January 26, 2024  
IDEA Donna Mechanical Upgrades

## ADDENDUM NO. 1

**02 IDEA DONNA CAMPUS - BASE BID  
NEW ENLARGED MECHANICAL PLAN (PRIMARY BUILDING)**  
SCALE: 1/4" = 1'-0"

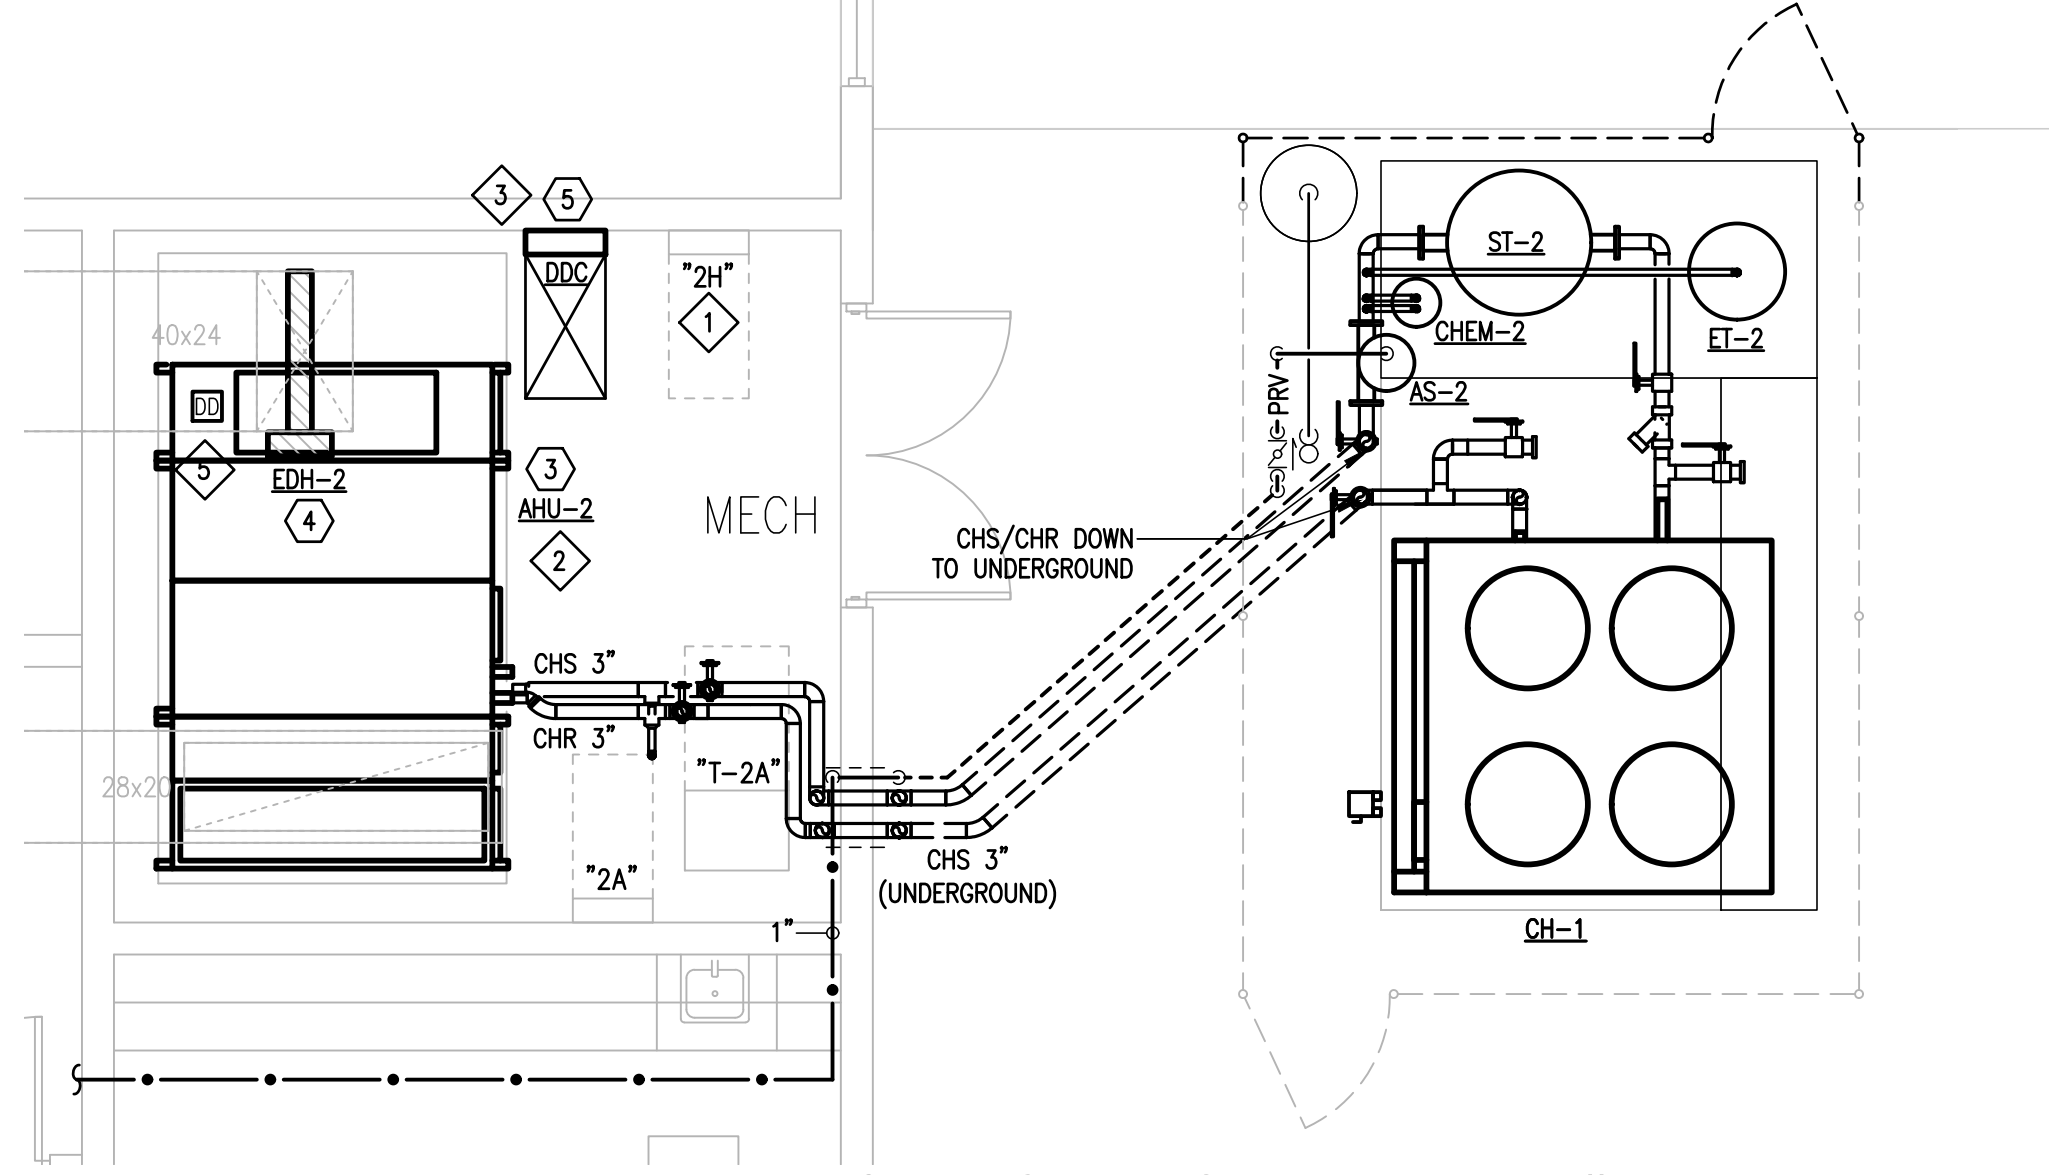
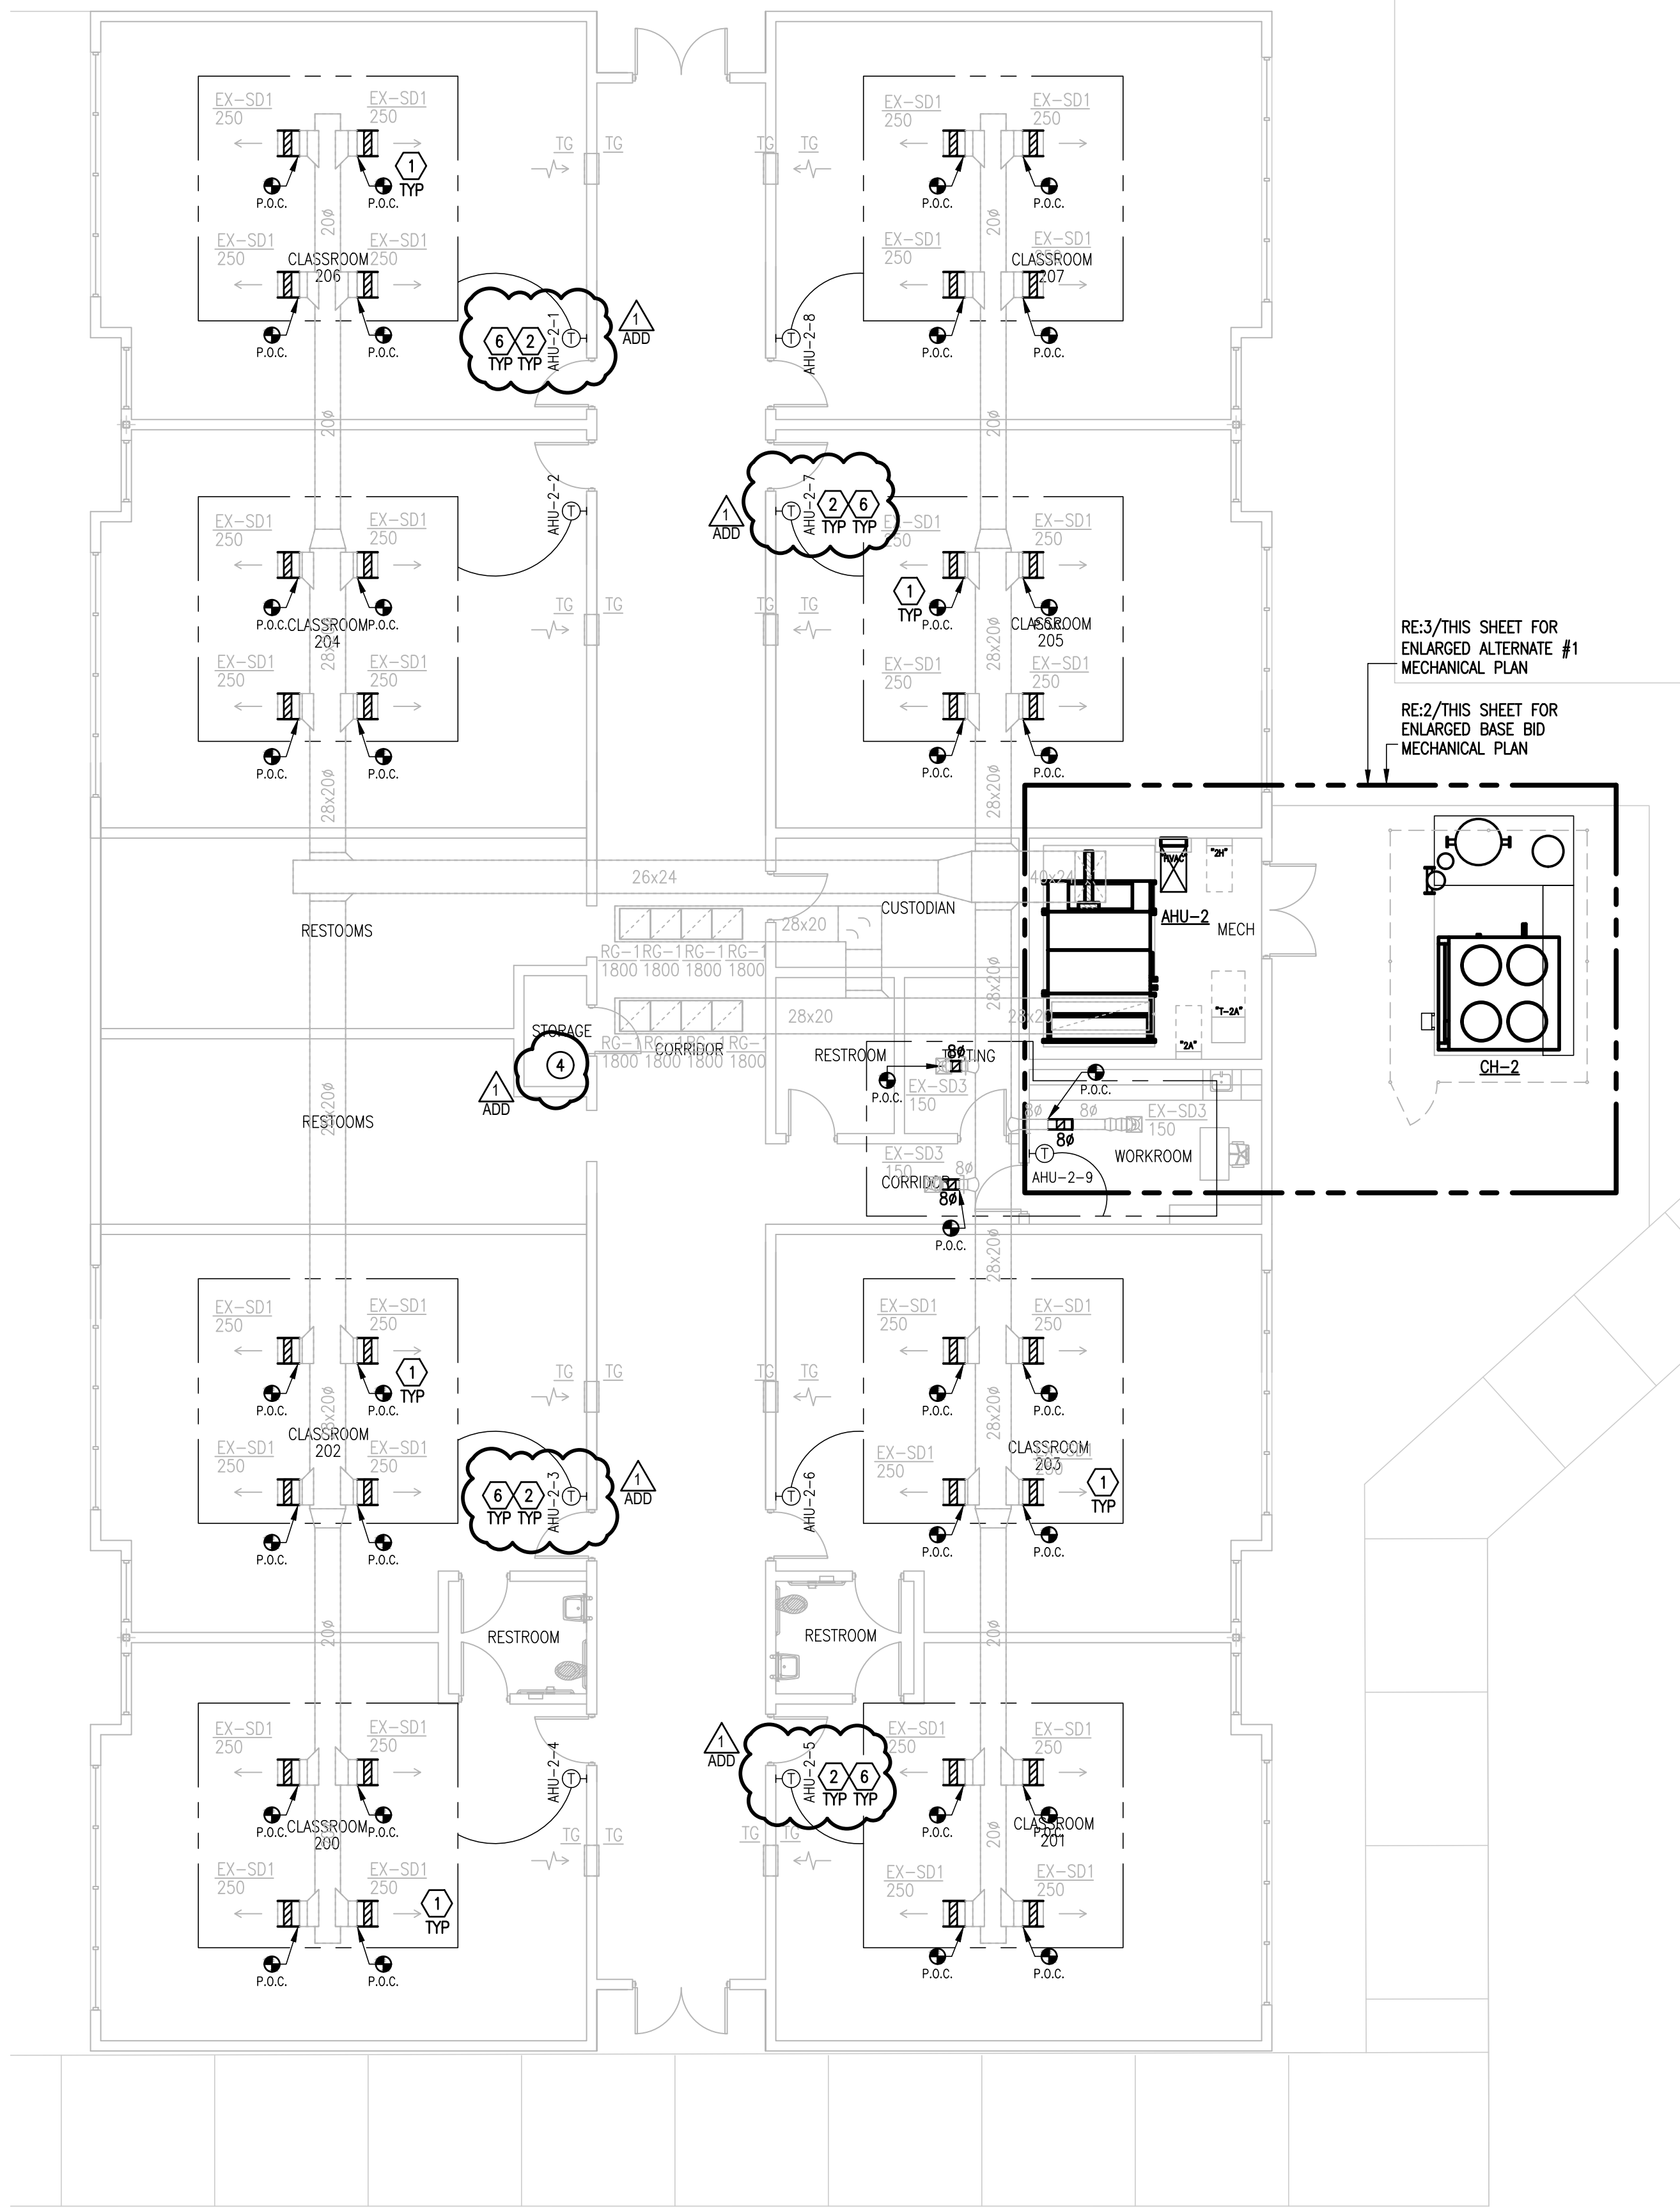
5. Sheet ME2.02:
  - a) Revised Base Bid New Enlarged Mechanical Plan. See attached sheet.
  - b) Revised Base Bid Electrical Keyed Notes. See attached sheet.
  - c) Revised Alternate #1 New Mechanical Plan. See attached sheet.
  - d) Revised Alternate #1 Electrical Keyed Notes. See attached sheet.
